Seismic Walkdown Checklist (SWC)Equipment ID No. RW-AOV-AO94 Equip. Class¹ 7Equipment Description Drywell Equipment Drain Sump Discharge (SWC# WD-SWEL-027 & AWC# WB-005)Location: Bldg. Rx Floor El. 881 Room, Area Above NW-TorusManufacturer, Model, Etc. (optional but recommended) Anchor Valve Co. 3"-150# Gate with Piston Type Act**Instructions for Completing Checklist**

Seismic Walkdown Checklist (SWC)

Equipment ID No. RW-AOV-AO94 Equip. Class¹ 7

Equipment Description Drywell Equipment Drain Sump Discharge (SWC# WD-SWEL-027 & AWC# WB-005)

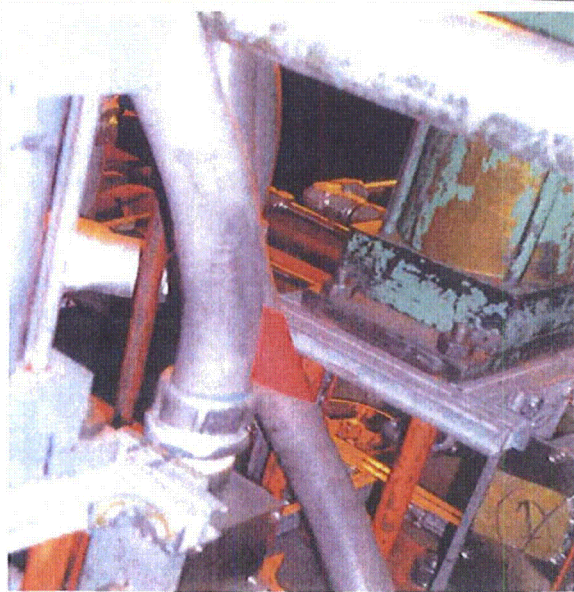
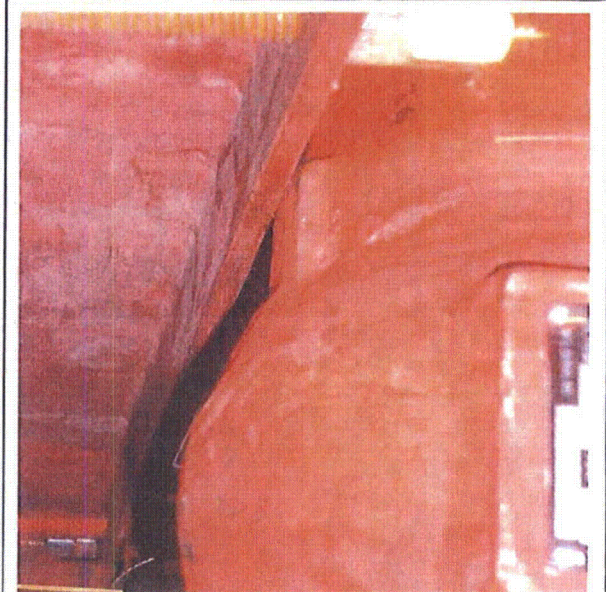
Flex conduit up against yoke body (frame). Valve body is in contact with a trapeze support system. By engineering judgment, the support will assist in restraining the valve, no issue.

Flex conduit is rubbing against the operator. By engineering judgment, it has been determined that both are seismically rugged. In the event of a seismic event, the conductors within the conduit will be able to perform there function.

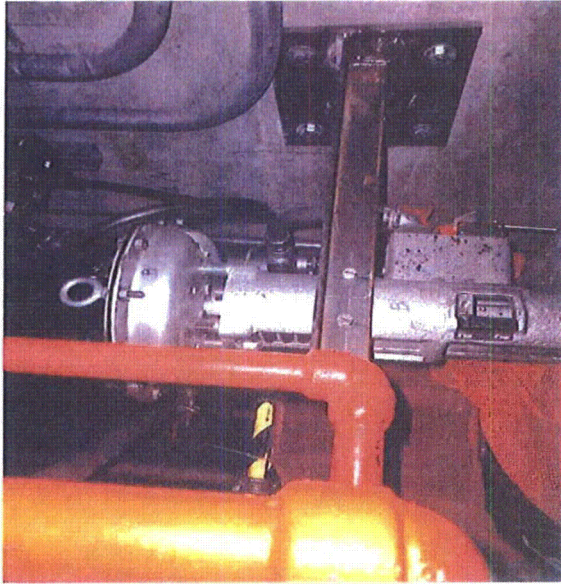
Valve operator has anchor frame on it, attached to nearby concrete wall with baseplate and anchor bolts. The support is in good condition. (Not shown on valve drawing E-191721), confirm support on valve yoke is in accordance with Seismic Qualification Report (SQR) of valve and pipe stress analysis.

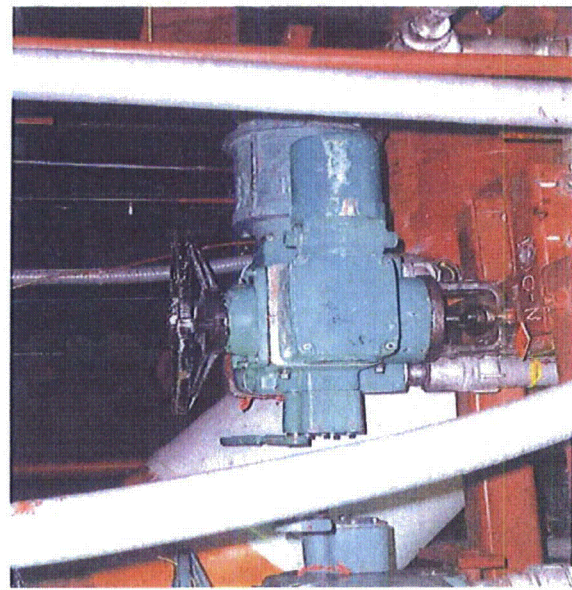
6. Based on the above anchorage evaluations, is the anchorage free of potentially adverse seismic conditions? Y ☐ N ☒ U ☐
*Tube steel frame around 3 of 4 sides at bonnet interface. No anchorage to concrete, only structural steel attachment (welded).
 Reference Drawing SBNI-H66A (SH. 1 and 2) and ISO 0640-012-TAP-SBL-03*

Tube steel documented in question 6 does not appear to be in a configuration acceptable by original analysis, further review required.

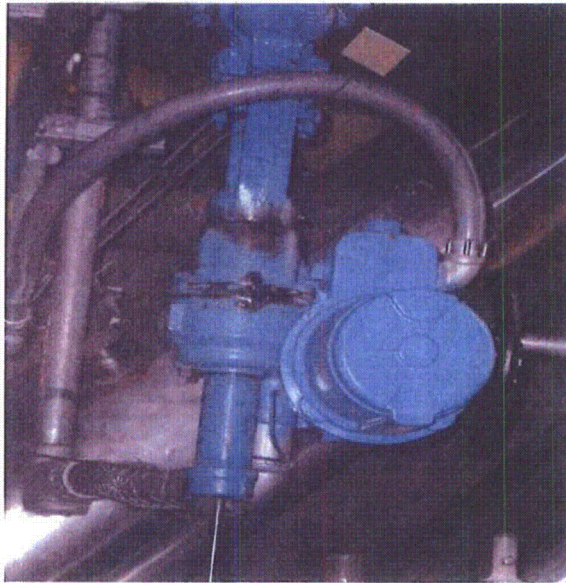
Grease appears to be leaking out of bonnet and yoke.
CR-CNS-2012-06264
